**DEFENSE NATIONAL STOCKPILE CENTER  
NEW HAVEN DEPOT  
RADIOLOGICAL OVERSIGHT REPORT**

**July 2004**

## **Executive Summary**

Figure 7. Ore on access road.

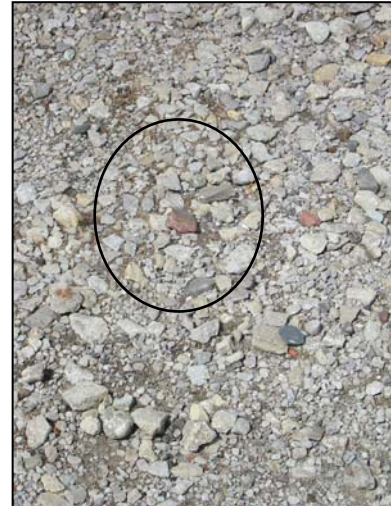
Pangea site management was unaware of areas included in the scope of work needing to be excavated. These areas include the road leading to Area 7A and the rail spur leading to Area 7A. Upon review of the contract, it was established that these areas are to be excavated. Figures 5, 6, and 7 show the rail line, access road, and ore that could be visually identified in the support zone.

- Review of contractual obligations of areas to be excavated.
- Submittal of estimated areas, depth and volumes that need to be excavated due to levels greater than the action level.
